Title - Sujet Microbiology Lab Construction - AAF	
Solicitation No. - N° de l'invitation EP922-210468/A	Amendment No. - N° modif. 004
Client Reference No. - N° de référence du client AAFC-EP922-210468	Date 2020-09-02
GETS Reference No. - N° de référence de SEAG PW-\$PWU-183-11877	
File No. - N° de dossier PWU-0-43069 (183)	CCC No./N° CCC - FMS No./N° VME
Solicitation Closes - L'invitation prend fin at - à 02:00 PM on - le 2020-09-10	Time Zone Fuseau horaire Mountain Daylight Saving Time MDT
F.O.B. - F.A.B. Plant-Usine: <input type="checkbox"/> Destination: <input type="checkbox"/> Other-Autre: <input type="checkbox"/>	
Address Enquiries to: - Adresser toutes questions à: Tikhonovitch (RPC), Alex	Buyer Id - Id de l'acheteur pwu183
Telephone No. - N° de téléphone (780) 901-7940 ()	FAX No. - N° de FAX (780) 497-3510
Destination - of Goods, Services, and Construction: Destination - des biens, services et construction:

Agriculture & Agri-Food Canada (AAFC)
Lacombe Research & Development Centre (LaRDC)
Microbiology Laboratory Remediation
6000 C&E Trail – Lacombe, AB
Project No. R.083193

ADDENDUM NO.1

8. Photos of CDP-SB1

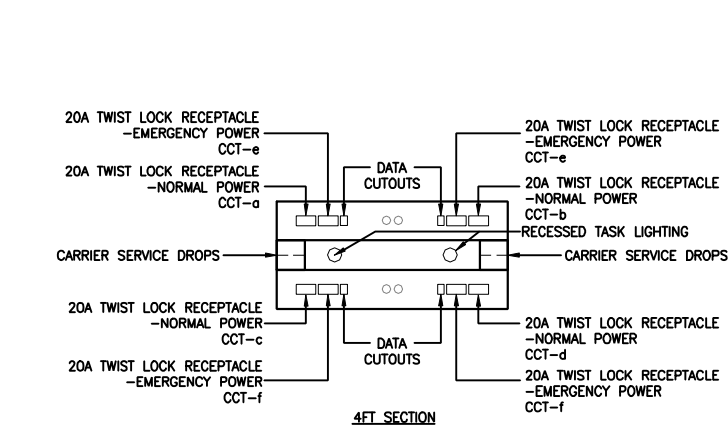
- 6.1. The existing access control system is Northern Computers, Inc. N-1000-IV. See photos below for access control system.
- 6.2. Manufacturer of existing distribution (electrical panels and CDP) are Eaton Cutler-Hammer. See photos below for CDP-SB1, CDP-BB1 and the 600A MCC.

1 SUSPENDED SERVICE CARRIER
EA01-01 SCALE: N.T.S.

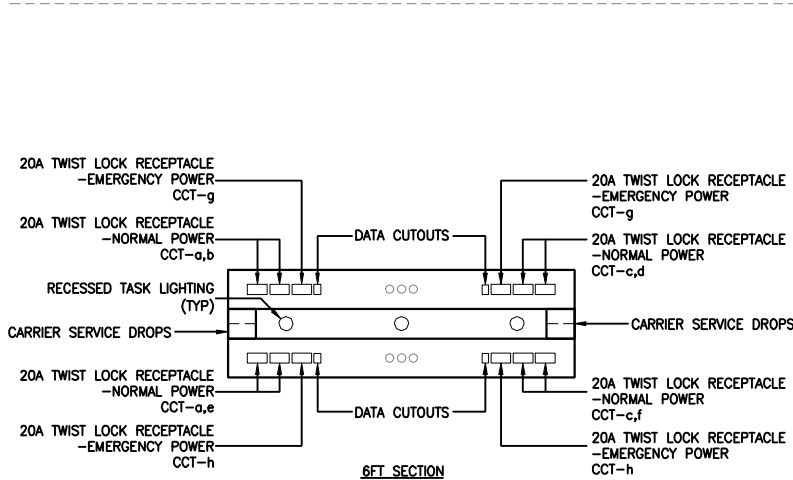
- 2.1. Refer to attached sketch SKEA01 and drawing E2.1 – Issued for Electrical Addendum E-01 for circuit number revisions to suspended carriers.
- 2.2. Suspended carriers and ceiling service panels are provided by others. Electrical contractor shall supply and install receptacles c/w backboxes and communication backboxes within the suspended carriers and ceiling panels. Contractor shall allow for miscellaneous coordination with successful vendor of service carriers.

- 2.3. Ceiling service panels receptacles shall be L14-20R.
- 2.4. Suspended carrier receptacles shall be L6-20R. Revise 6ft carrier to have a total of two (2) circuits on standby power.

5 BUILDING SECTION
SCALE 1/8\"/>

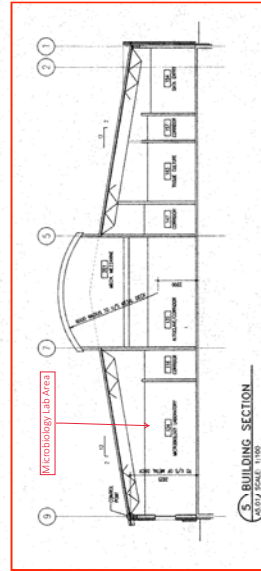
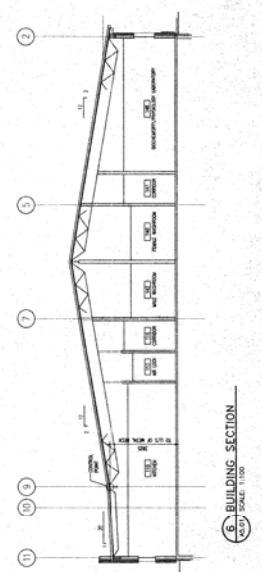
1. Existing roof assembly above Microbiology Lab 124 is a single sloped roof.
2. Underside of roof deck at exterior wall (low edge) = 3925mm AFF
3. Underside of roof deck at roof-wall transition above Corridor 116 (high edge) = 5580mm AFF

\$2.00

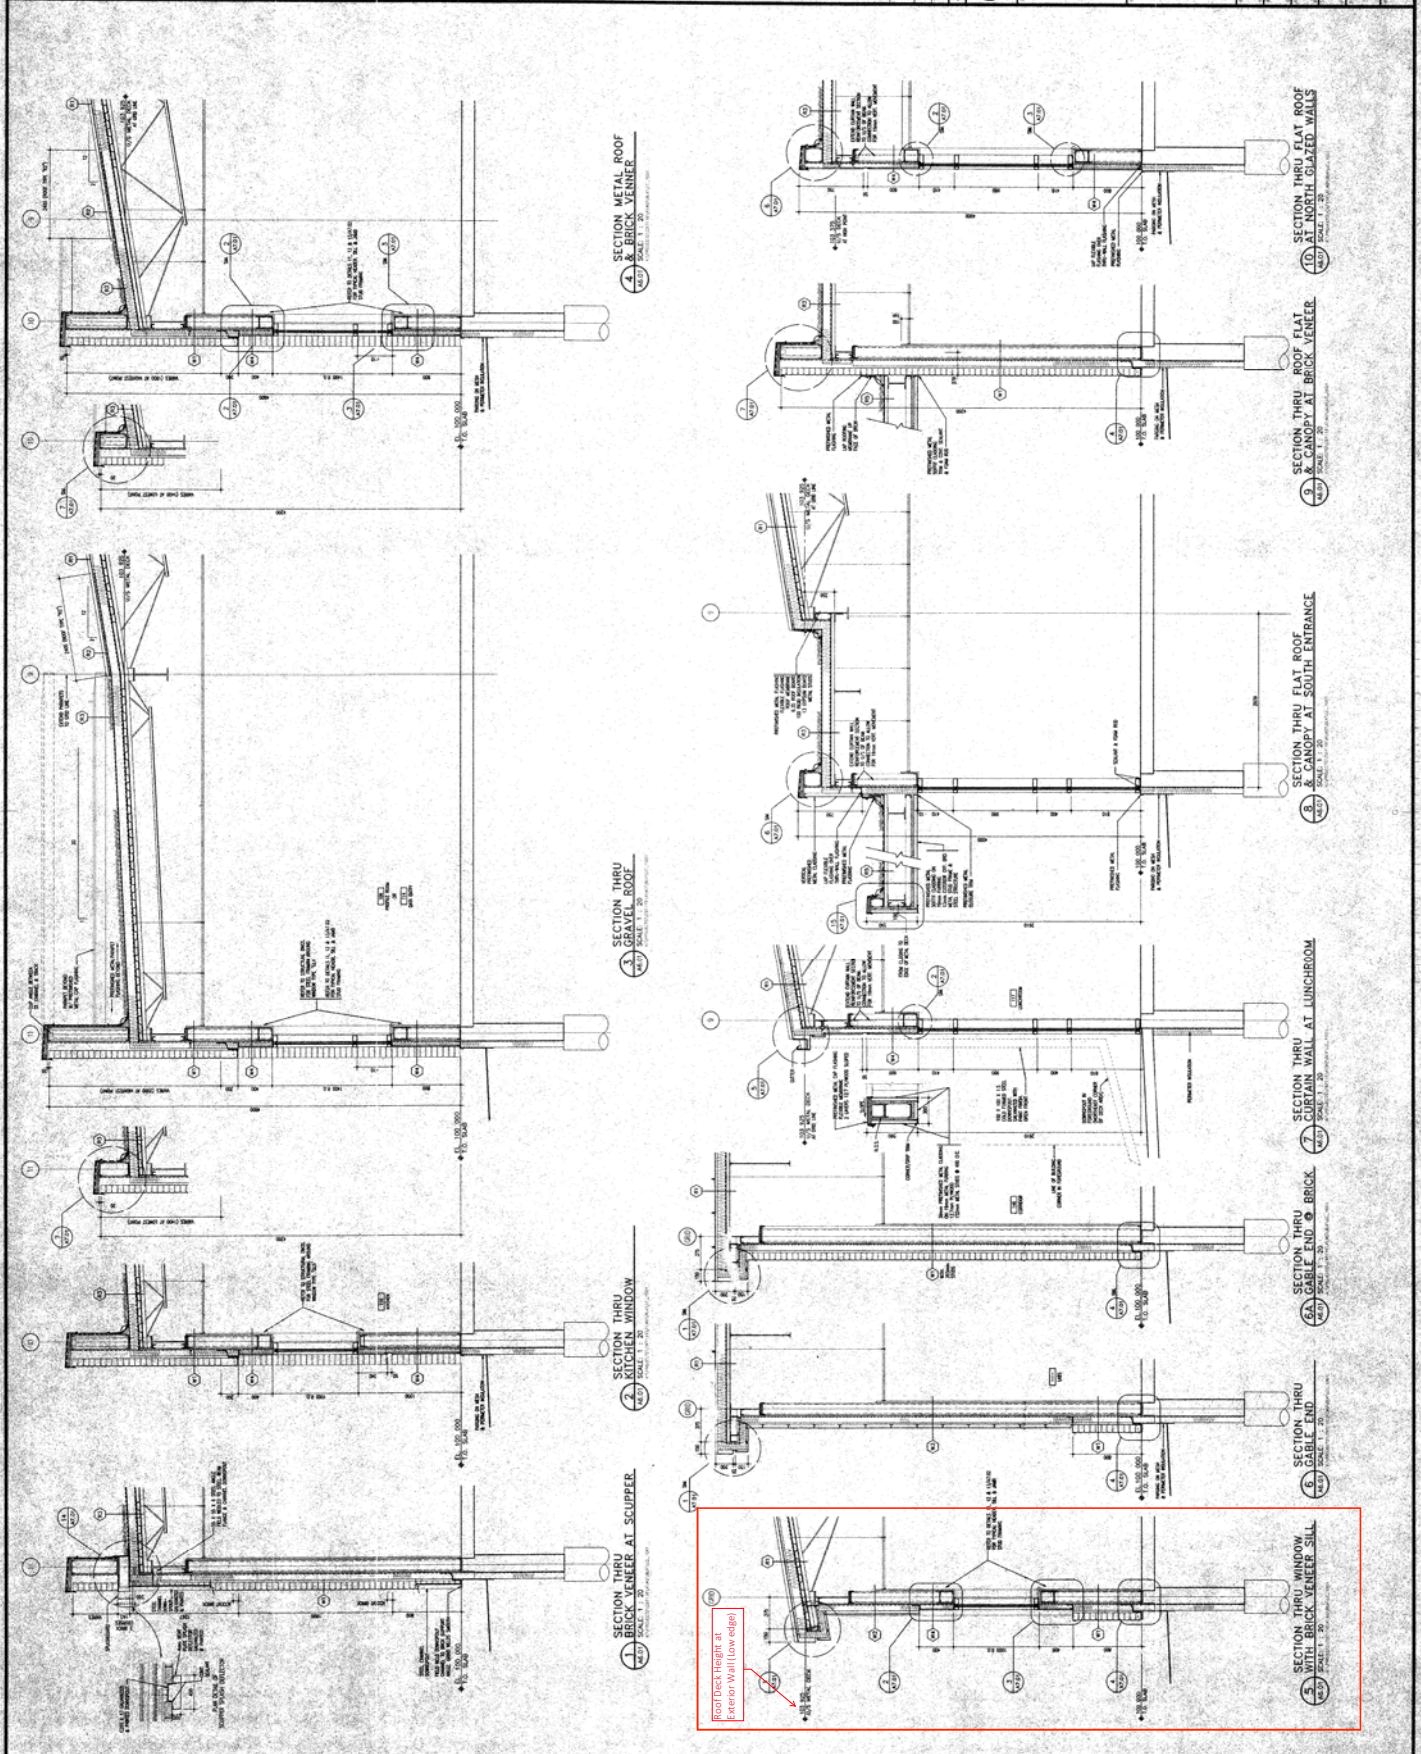
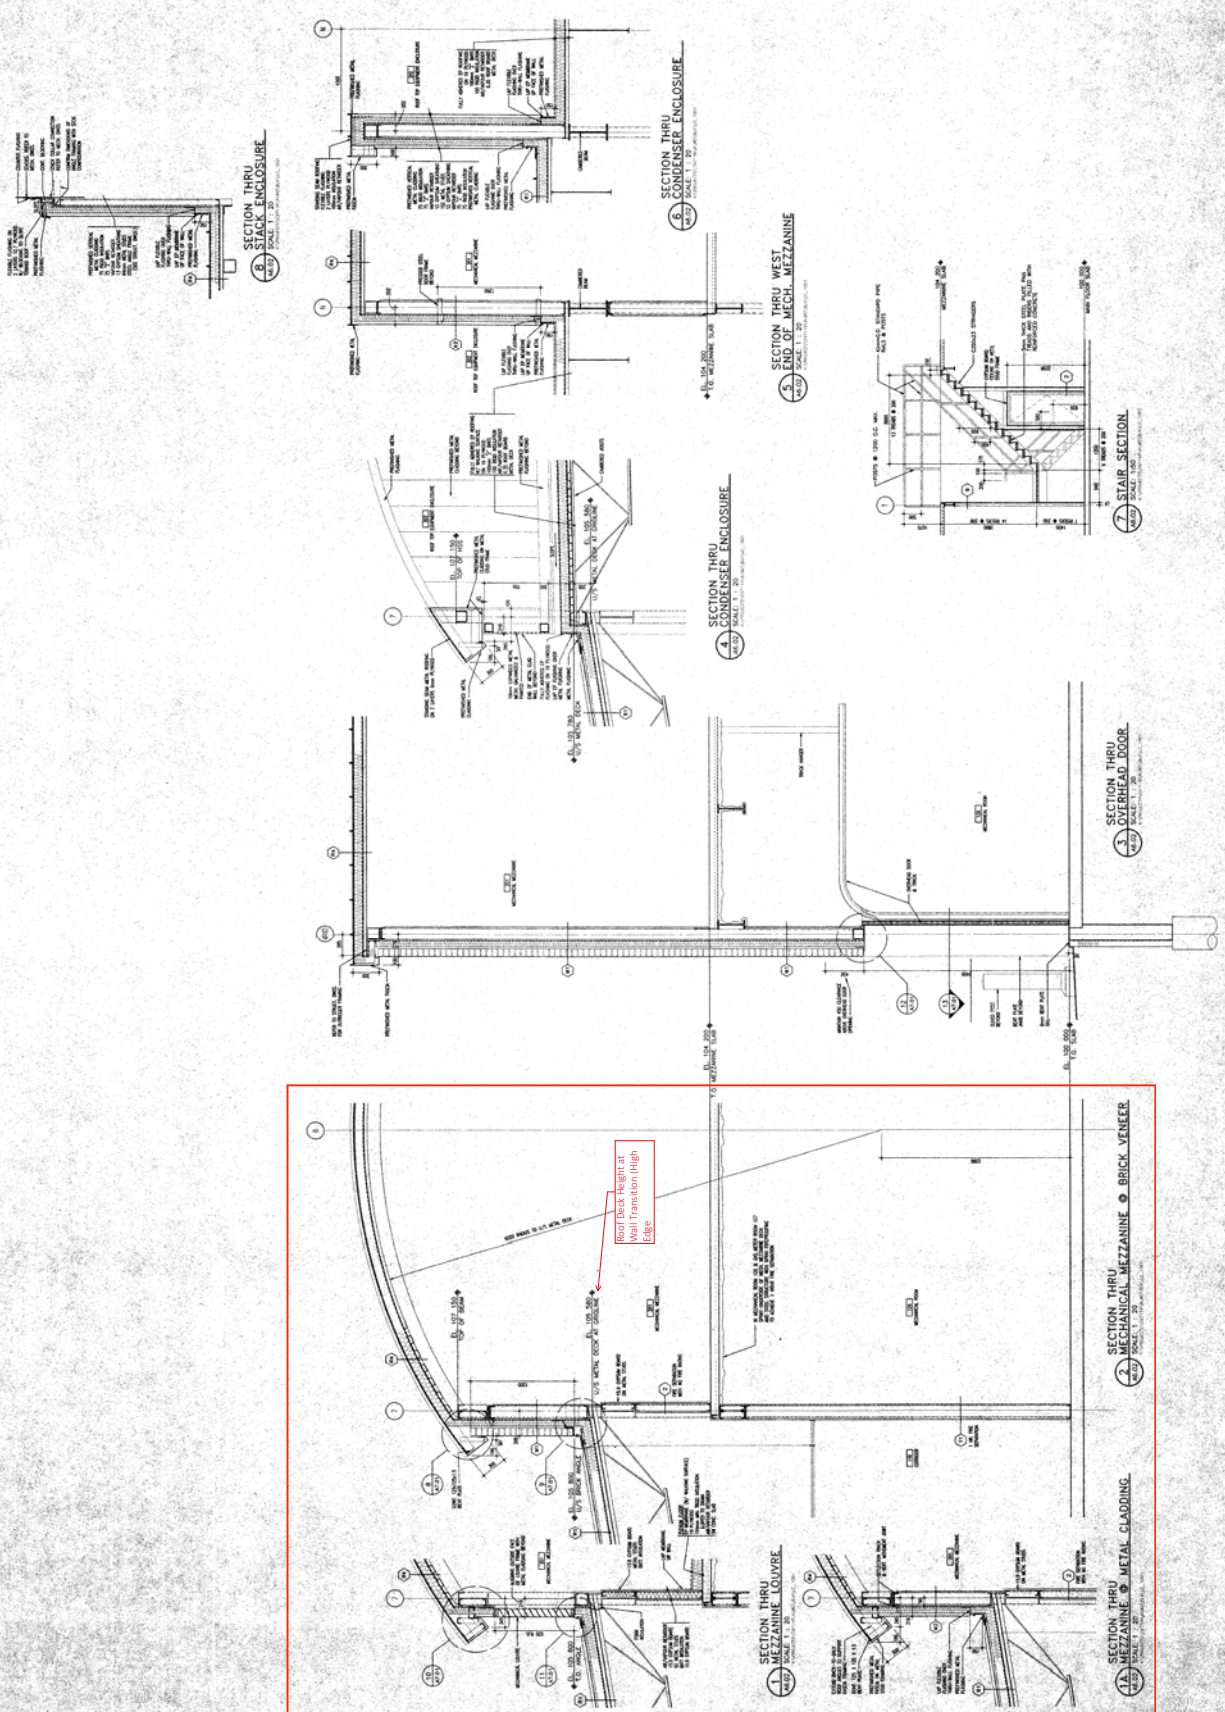
1. Record drawings indicate existing concrete slab to be: 125mm thick slab on grade r/w 10M rebar @ 300 each way, mid depth. New infill locations to match existing concrete and reinforcing. Epoxy dowel into existing slab, both sides of infill, ensure sufficient embedment depth.
2. Structural engineering not part of consulting scope of services. Contractor to determine reinforcing/concrete placement details and submit shop drawings for review.
